## STERN DRIVES/INBOARD ENGINES

NUMBER: 80-6

DATE: 3/12/80

- A. MCM 470 Cylinder Head Gasket
- B. MCM 470 Heat Exchanger Mounting Bracket
- C. Temperature Gauge Resistor B-82-88645A3 for MCM 470/485 and MIE 470 Engines
- D. Alternator Rotor Remover
- E. MCM 470 Power Steering Pump Installation
- F. MerCruiser Inboard Transmission Fluid
- G. MIE 228/255/330 Cylinder Block Replacement
- H. MerCruiser Crankcase Oil Recommendations
- I. Condenser B-392-6324 Shorting Problem

Figure 1. Condenser

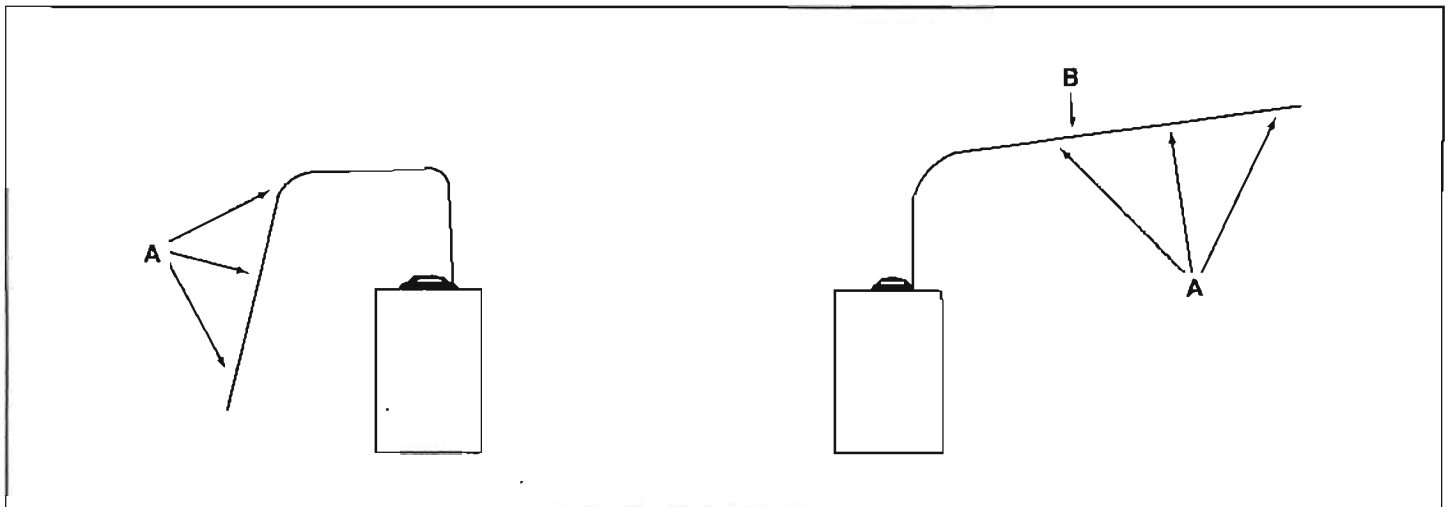
Condenser B-392-6324 (Figure 1) is used in Prestolite distributors on MCM 888, MCM 233 and MIE 233. The condenser has a copper strap with 3 mounting holes. When installing a replacement condenser, it is necessary to bend the strap in the opposite direction (180°) and to cut the strap off at the hole next to the condenser. (Figure 2) If this procedure is not followed, the copper strap will short out to the distributor housing.

a - Mounting Holes in Copper Strap  
b - Location to Cut Off Copper Strap
